Report: Sweathouz Punchlist
Function: Test, Adjust, & Balance
Date: 03/12/2025
Completed By: National TAB

PROJECT
SWEATHOUZ RENOVATION (WEST
CHESTER, OH)

Issue List

1 FLOOR PLAN - MECHANICAL
1/4" = 1'-0"
NORTH

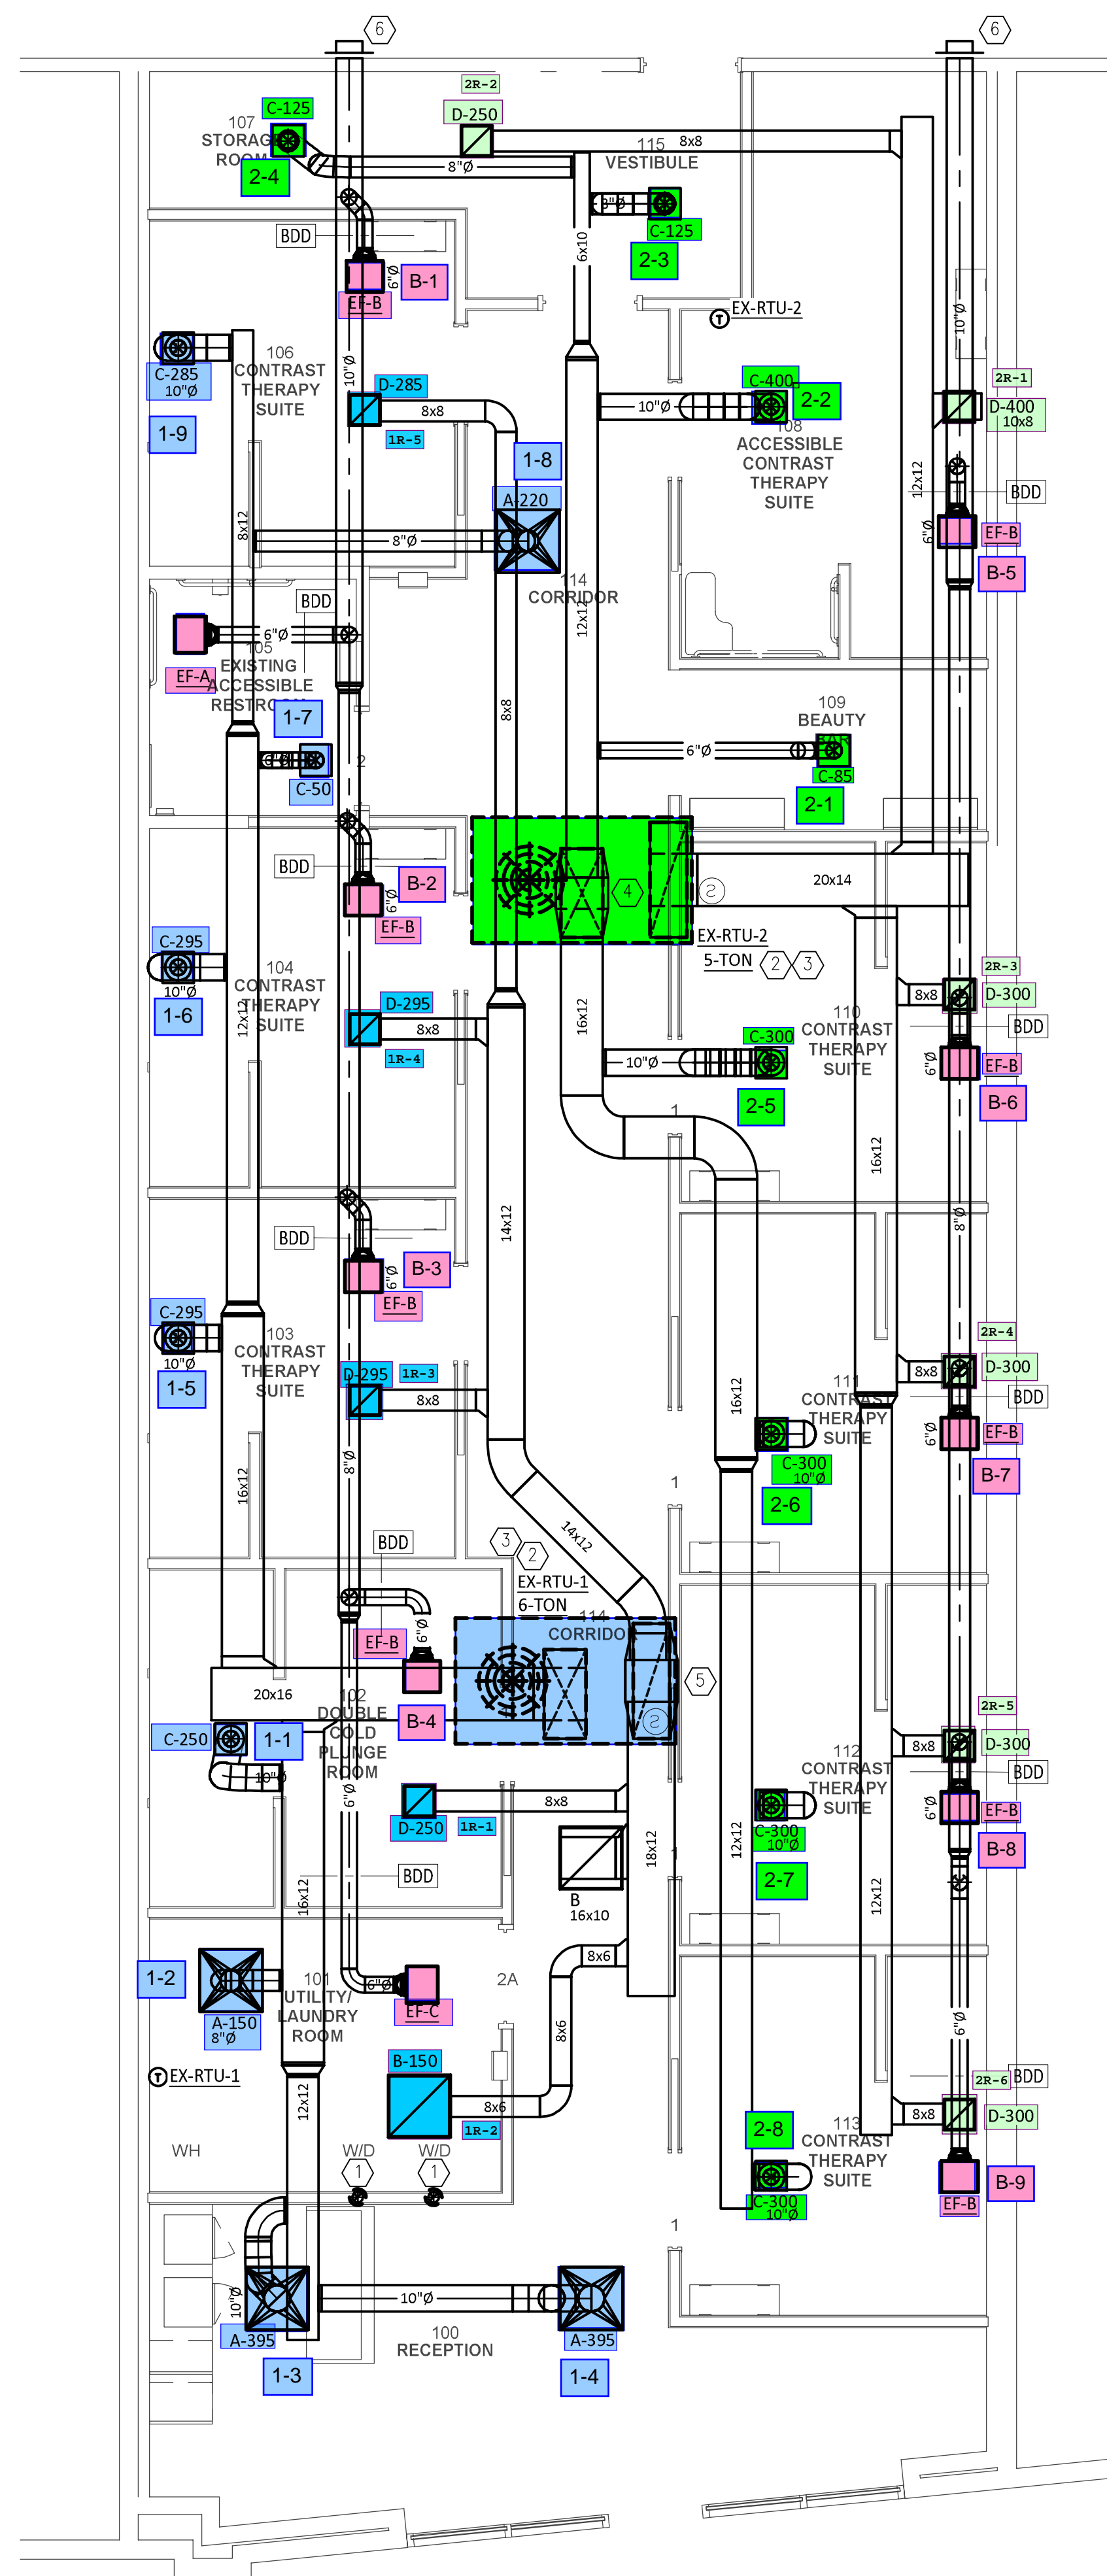
Issue Name : EF-B5.
Description : EF-B5 incorrect fan installed. Fan does not match other installed fans. Fan does not have a speed controller. Fan is not sealed at the ceiling.
Created By : National TAB **Assigned To :** National TAB - Nick Payne
Status : Open
Priority : Urgent **Asset Tag :** EF-B5
Originated Date : 03/12/2025 - Cody Collett - National TAB

Issue Name : RTU-1 always running heat.
Description : RTU-1 always running heat regardless of demand.
Created By : National TAB **Assigned To :** National TAB - Nick Payne
Status : Open
Priority : Urgent **Asset Tag :** RTU1
Originated Date : 03/12/2025 - Cody Collett - National TAB

Issue Name : RTU-1 and RTU-2 no occupied signal.
Description : RTU-1 and RTU-2 not receiving an occupied signal and due to this the economizers will not open.
Created By : National TAB **Assigned To :** National TAB - Nick Payne
Status : Open
Priority : Urgent **Asset Tag :**
Originated Date : 03/12/2025 - Cody Collett - National TAB

Issue Name : RTU-1 final filters clogged/Possible partially clogged coil.
Description : RTU-1 all final filters are clogged(must be replaced). Top left final filter fell and there is a significant amount of dust on the fan blades and in the motor compartment indicating that due to the filter falling a significant amount of dust filled air went through the coils unfiltered.
